APPEAL RECOMMENDATION REPORT

City Planning Commission

Case No.: ZA-2018-7378-ZV-TDR-SPR-1A

PROJECT LOCATION: 1123-1161 South Main Street; 111 West 12th Street

③ Plot Plan-MAIN STREET EASEMENT 2
3/32" = 1'-0"

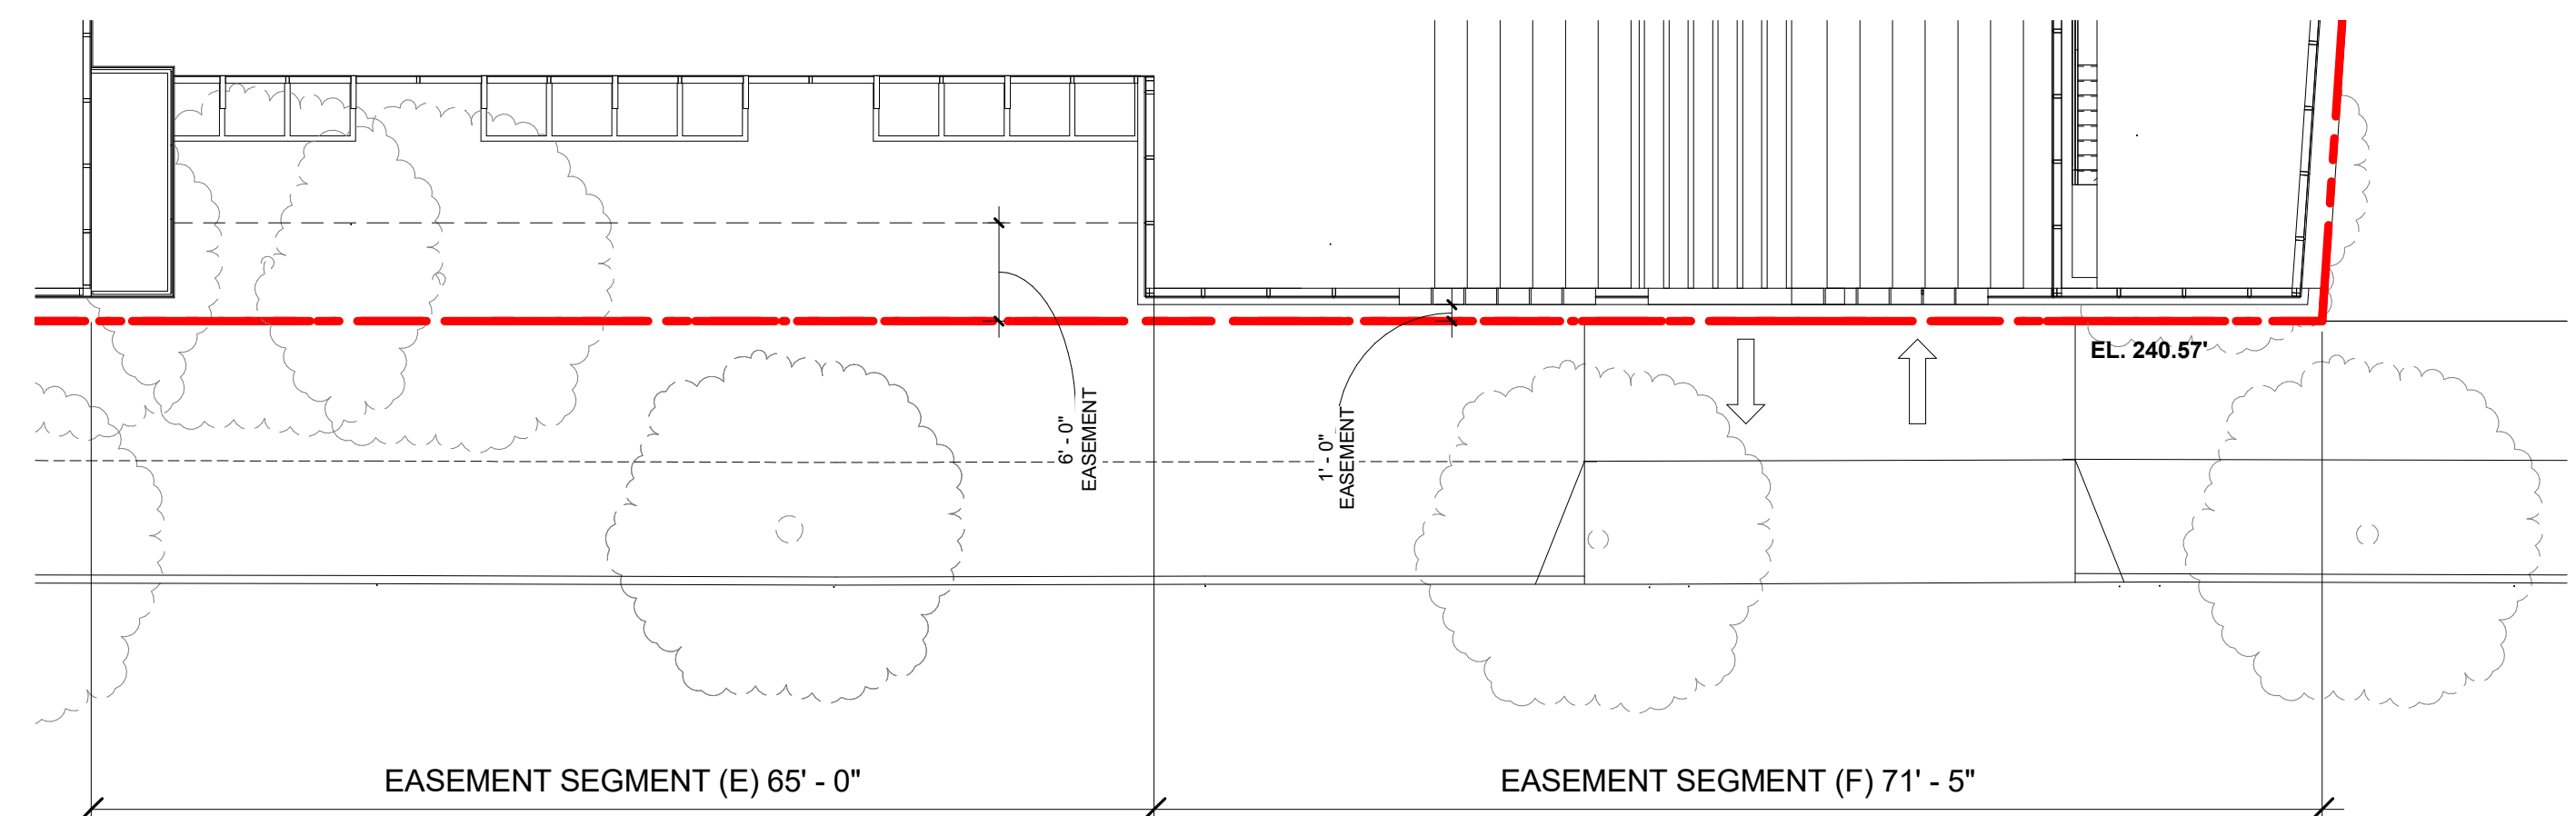
- a. **Sidewalk Easement.** The project shall provide an average sidewalk easement of three feet along 12th Street and two feet along Main Street, as shown on Sheet A0.01.1 of Exhibit "A." The building shall not project more than five horizontal feet over the required sidewalk easement nor below 40 vertical feet above the sidewalk.

- a. **Sidewalk Easement.** The project shall provide an average sidewalk easement of three feet along 12th Street and two feet along Main Street, as shown on Sheet A0.01.1 of Exhibit "A;" **stamp-dated August 18, 2022.** The building shall not project more than five horizontal feet over the required sidewalk easement nor below 40 vertical feet above the sidewalk.

shown on Sheet A0.01.1 of Exhibit “A” **stamp-dated August 18, 2022,** the project proposes an average sidewalk easement of 2.20 feet along Main Street and 3.04 feet along 12th Street and therefore complies with the sidewalk easement requirements.

② *Transverse Section-Spacing Diagram
1" = 20'-0"

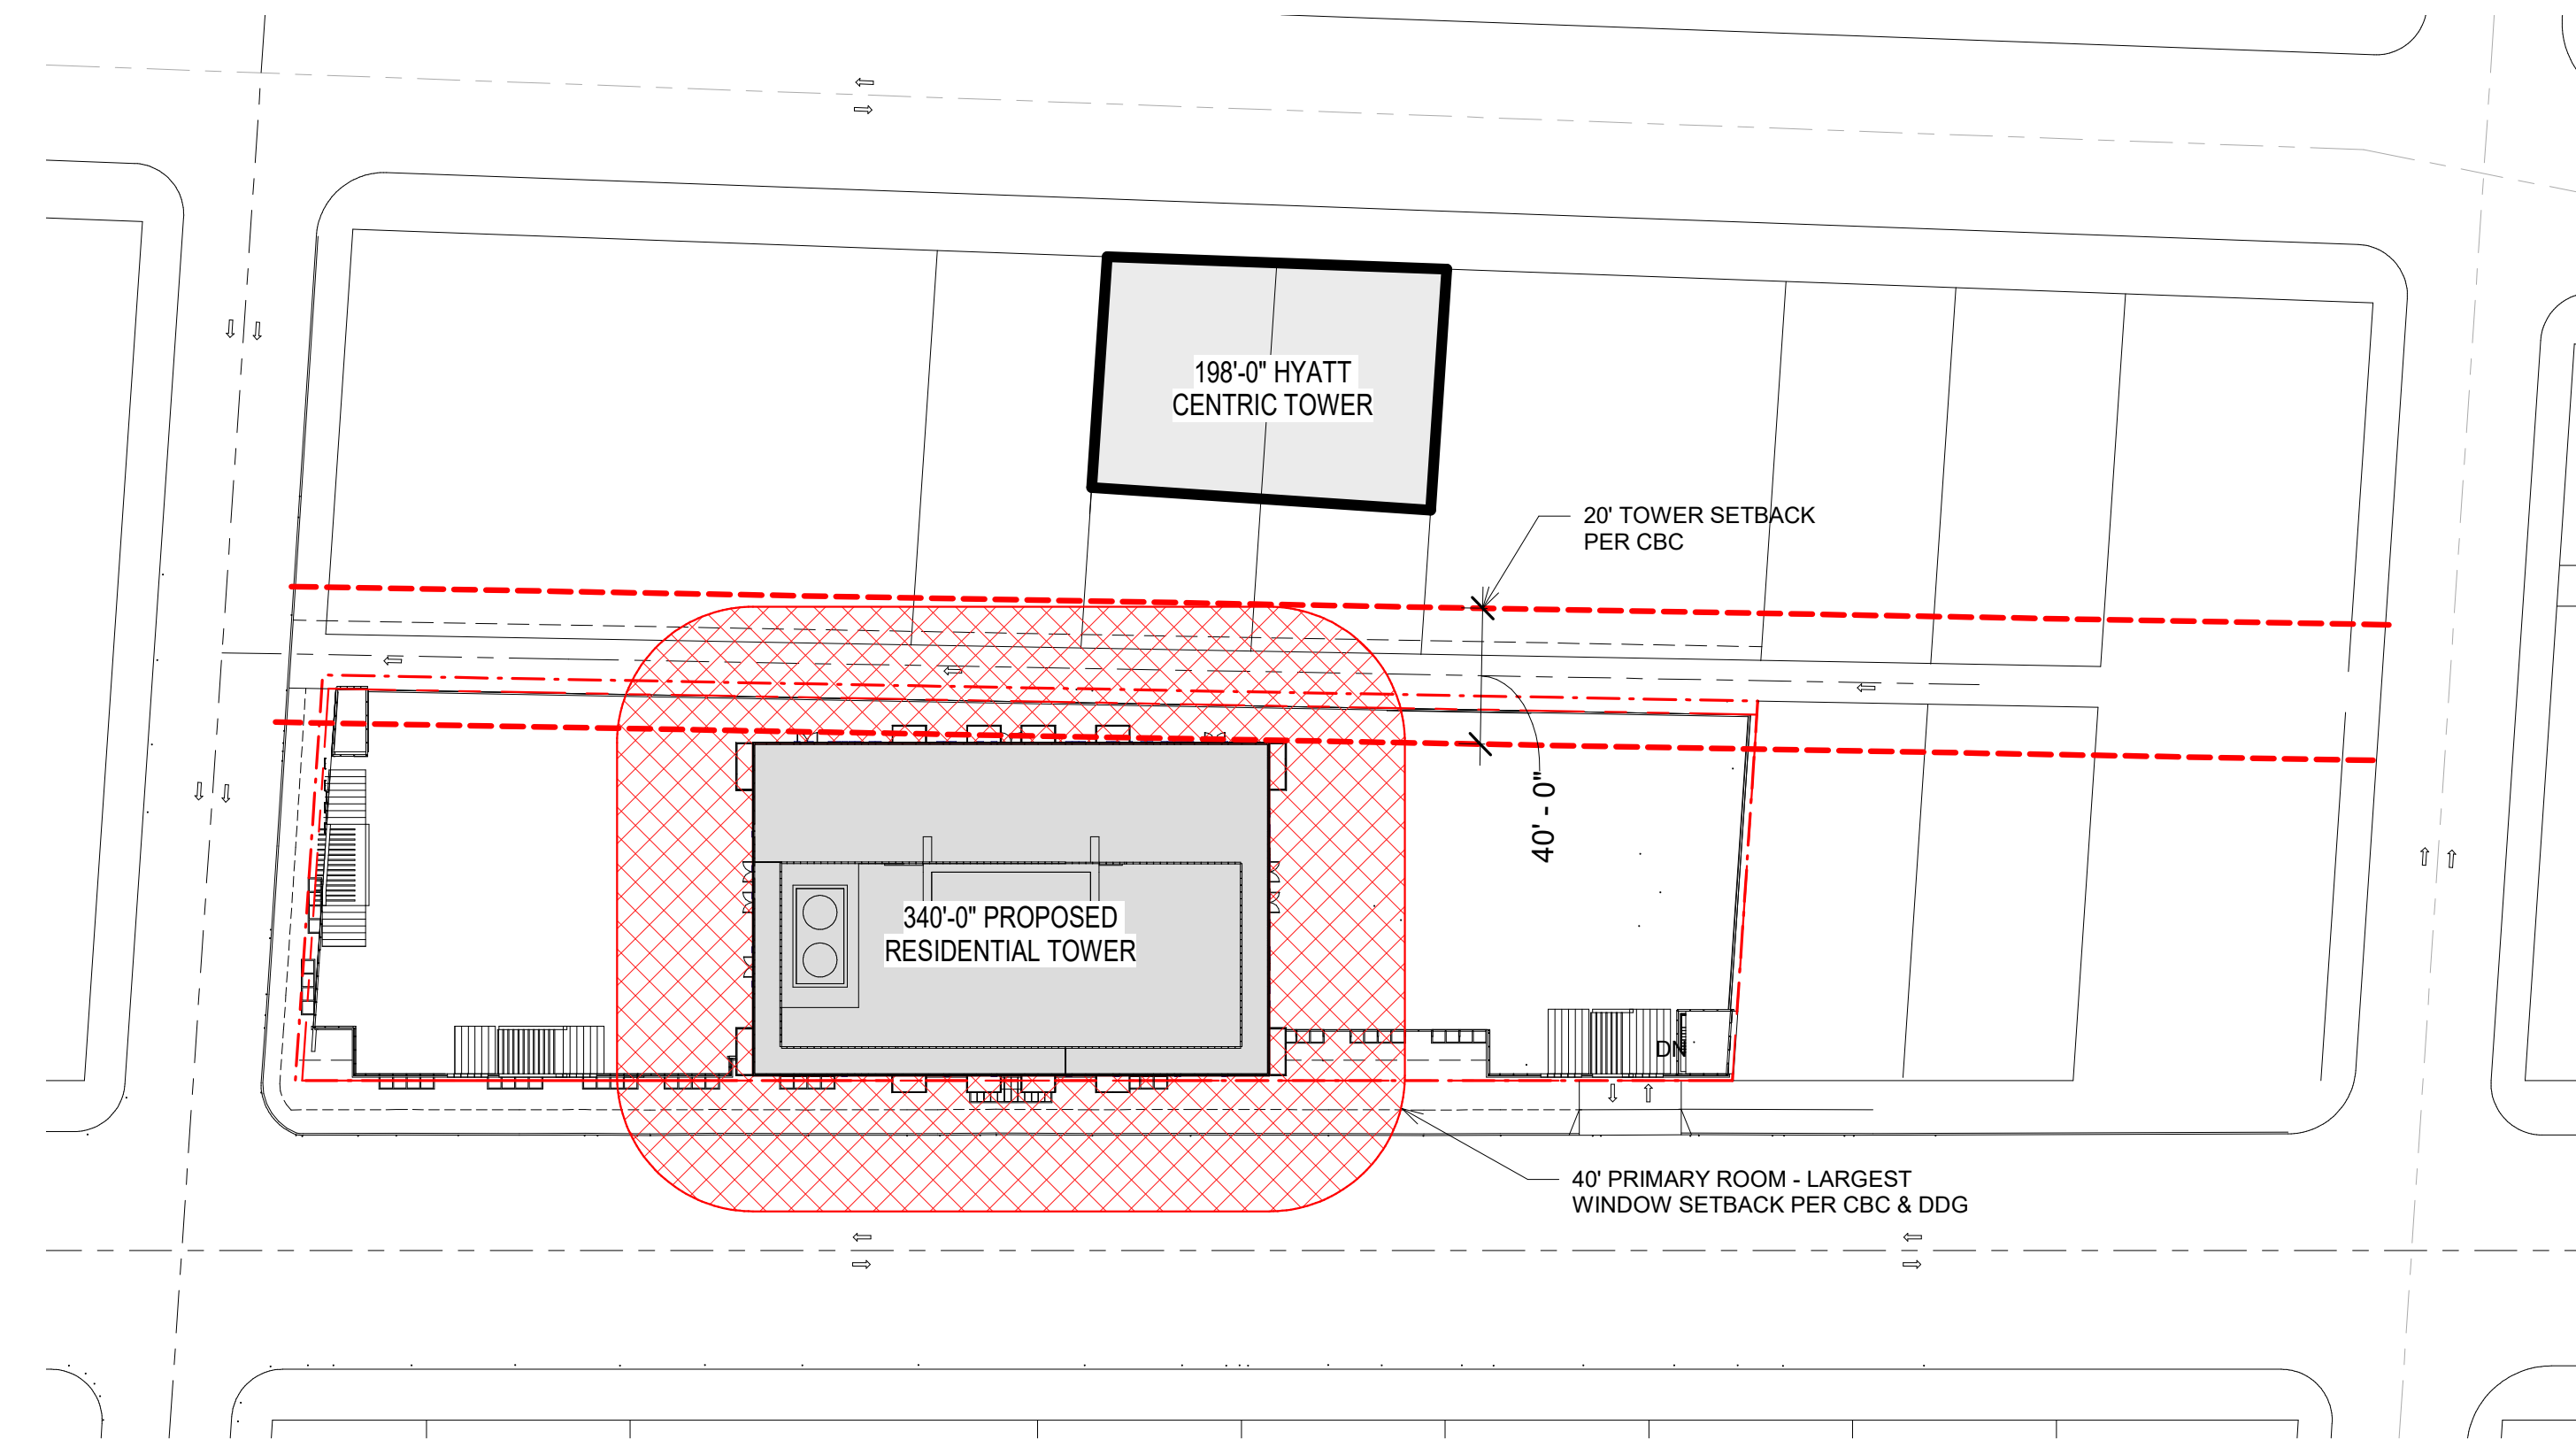
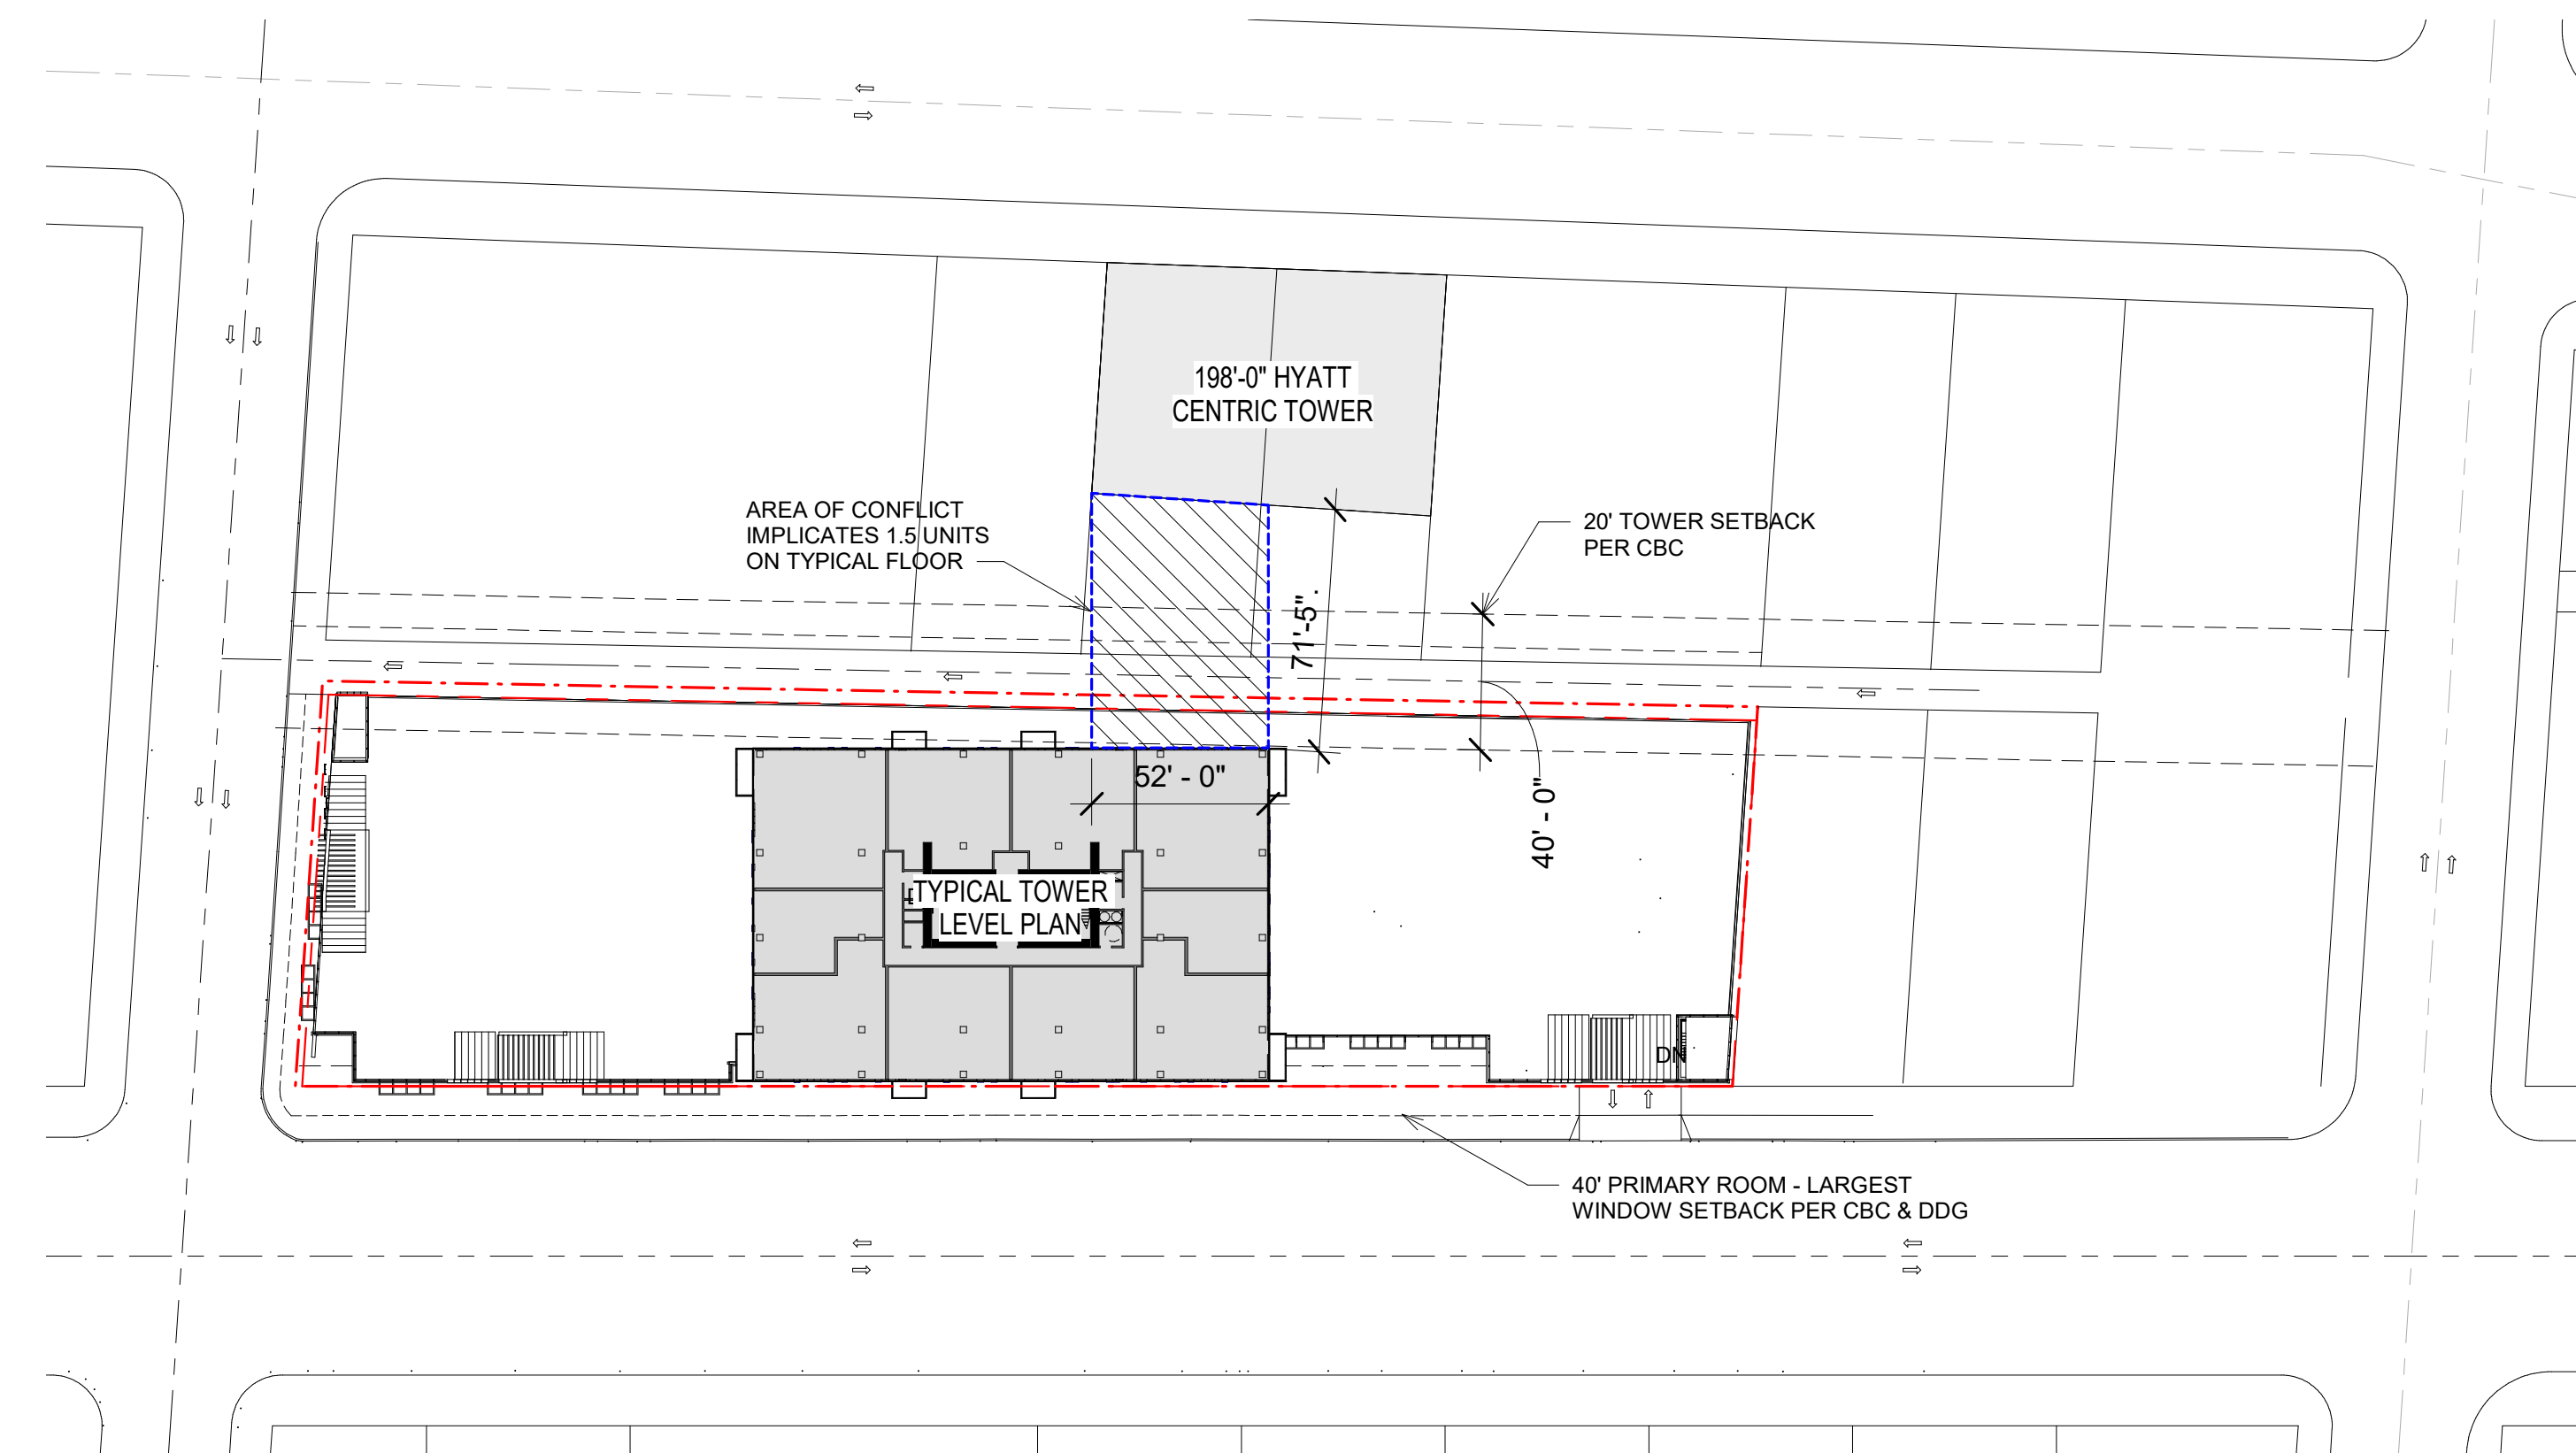
The Project's building (tower) arrangement, height, bulk, and setbacks are not compatible with the hotel abutting the Subject Property northerly. The tower would be better situated southerly, away from the hotel. Therefore, the Site Plan Review should not be granted for the Project's current design.

Regarding arrangement and setbacks, the project site is not subject to any setback limitations per the Greater Downtown Housing Incentive Area. Furthermore, the Downtown Design Guide requires the building street wall adjacent to retail use to be located at or within zero to five feet from the required sidewalk easements to activate streetfronts. As such, the proposed building is encouraged to be built close to, if not at, the property lines. Additionally, as previously mentioned, the Downtown Design Guide regulates space of towers, and as illustrated on Sheets 0.04 and 0.05 of the project plans (Exhibit A), the project tower is proposed to be offset or staggered from the tower proposed at the appellant's property at 1140 South Broadway. The proposed tower is separated from the 1140 South Broadway tower by approximately 71 feet and maintains sightline distances of greater than 40 feet between two buildings as required by the Downtown Design Guide.

- c. **Tower Spacing.** The proposed tower shall be located a minimum of 71 feet from the proposed hotel tower located at 1140 South Broadway, as shown on Sheet **s A0.04 and** A0.05 of Exhibit "A" **stamp-dated August 18, 2022.**
